# SERVICE BULLETIN

AIR — ENGINE AIR-ACTUATOR, VARIABLE STATOR VANE — INTRODUCTION OF  
PRODUCT IMPROVEMENTS TO TYPE G4000 SERIES ACTUATOR

V2500 Series 75-0128

# V2500-ENG-75-0128

LOCATION OF VARIABLE STATOR VANE ACTUATOR  
75-32-41  
FIGURE 1

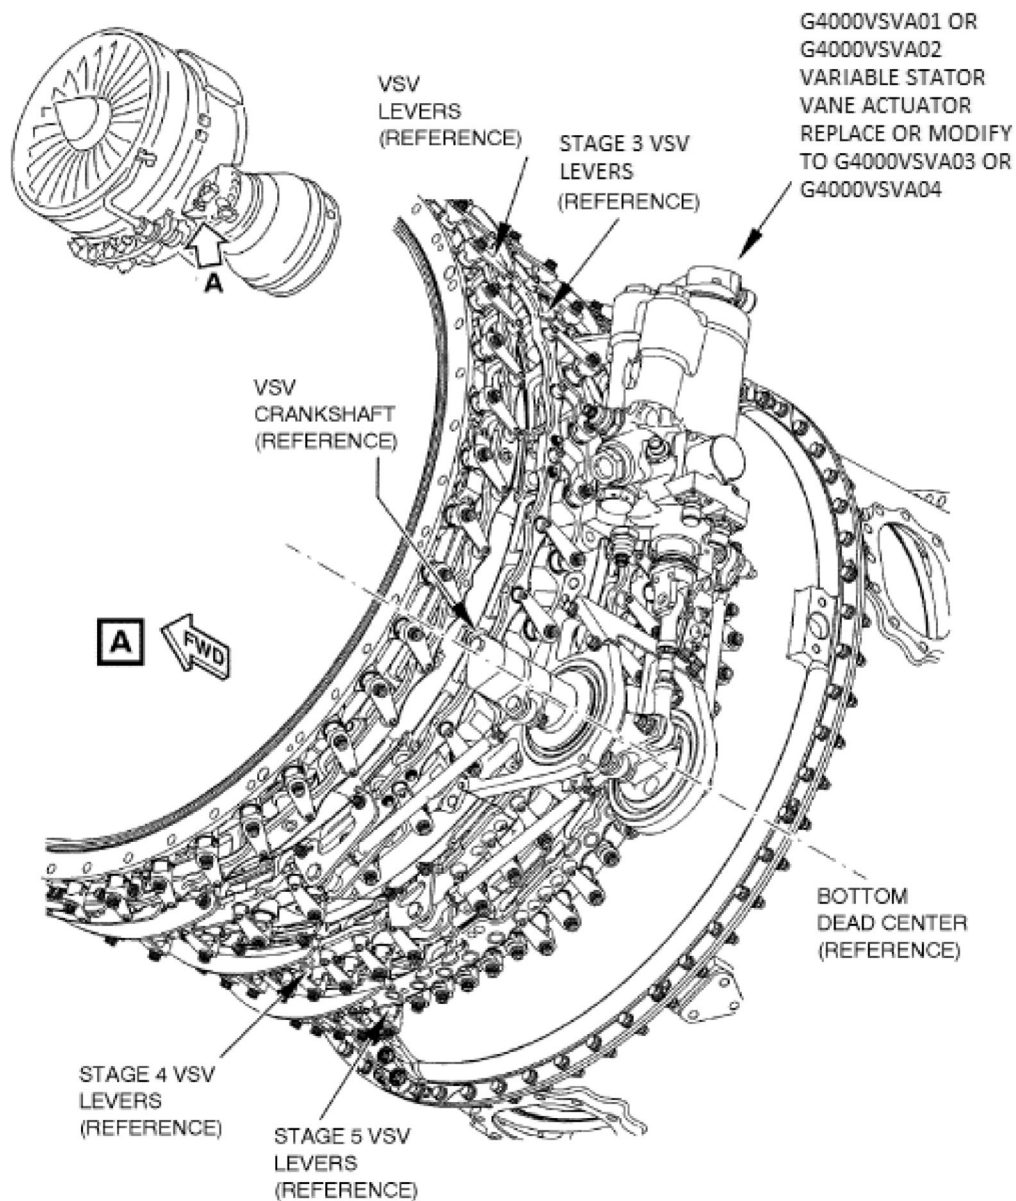
1. Condition: VSVA tight fit with High Pressure Compressor (HPC) case dowel pins may cause 1) Dowel pin fracture on installation. 2) Damage to the torque motor cover. Other conditions identified: 3) Clogged torque motor servo valve screens. 4) Single channel intermittent open circuit of Linear Variable Differential Transformer (LVDT).

3. Objective: 1) Increase VSVA body inner mounting foot dowel pin locating hole diameter; 2) Add "DO NOT HIT" etch to the torque motor cover to remind not to use as a striking point; 3) Increase the torque motor servo valve screens mesh size to maximum allowable and still protect nozzle and torque motor flapper clearance; 4) Provide new LVDT utilizing assembly processes /material that do not contain chlorides and improve the surface finish of the electrical connector housing seal areas.

1. Replace the VSVA, PN G4000VSVA01 or G4000VSVA02 with PN G4000VSVA03 or G4000VSVA04. See Figure 1.
2. Return the removed VSVA to the vendor identified in the Vendor Services section for modification.
  - A. Modify PN G4000VSVA01 to PN G4000VSVA03 as specified to Reference 8.
  - B. Modify PN G4000VSVA02 to PN G4000VSVA04 as specified to Reference 9.
3. Recording Instructions
  - A. A record of accomplishment is necessary.

## VARIABLE STATOR VANE ACTUATOR CHART A

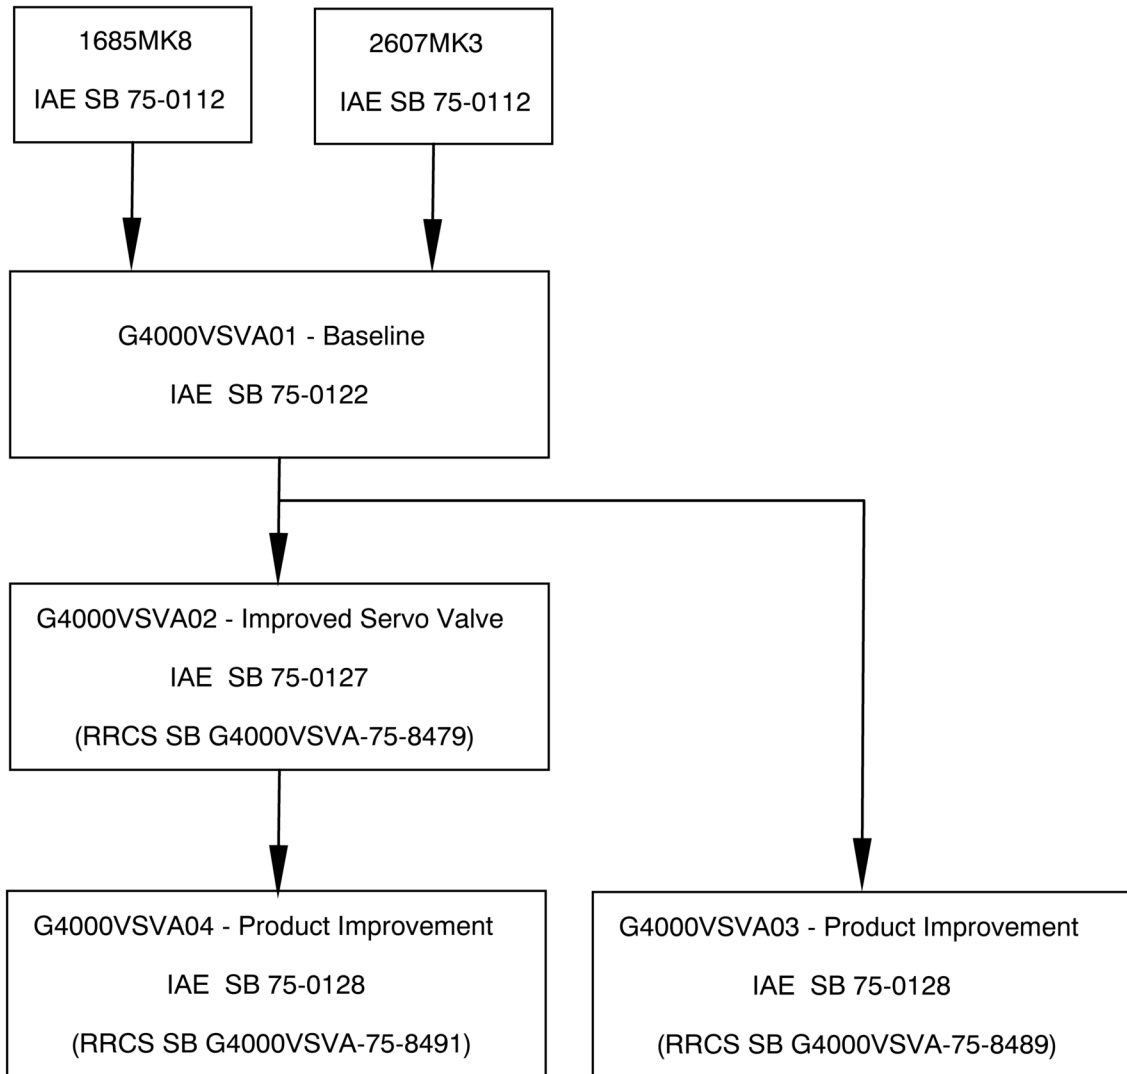
Parts Progression To Show the Changed Part in Relation to Other Parts
